# **Norwich Western Link**

## **Drainage Strategy Report**

### **Appendix 2: Third Party Liaison**

Document Reference: 4.04.02

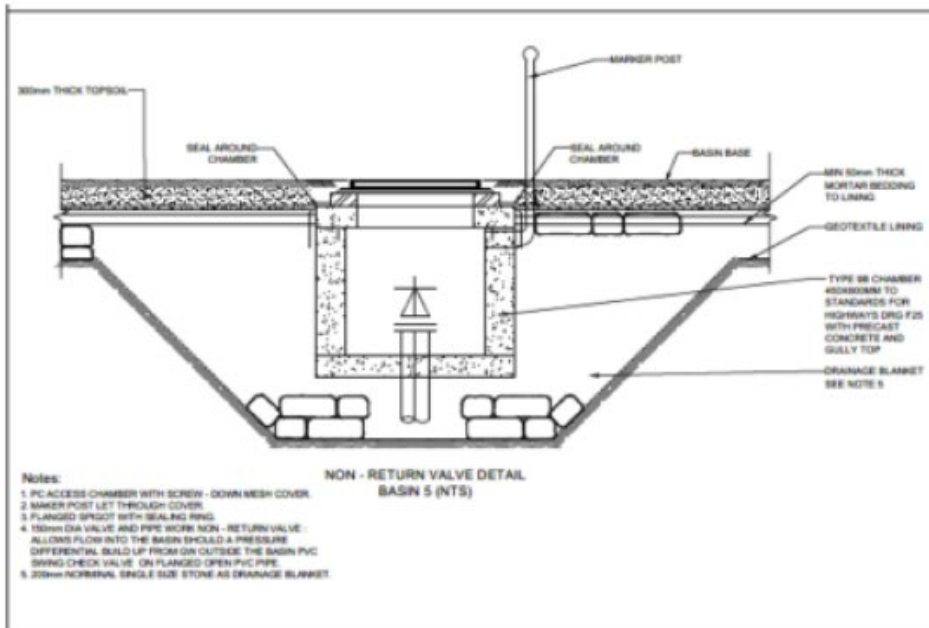
Further to a recent design review meeting held between NCC, the NWL team and Ferrovia Construction we require confirmation by return email that the detail as shown on drawing PK1002-HDG-MLE-DE-DZ-0005 is acceptable to be installed at the bottom of basin 5. This MH will relief the potential pressure coming from high ground water levels.  
If you have any queries please do not hesitate to contact --- or myself

Hi  
As discussed yes happy by return email that the with Detail on drawing for basin 5
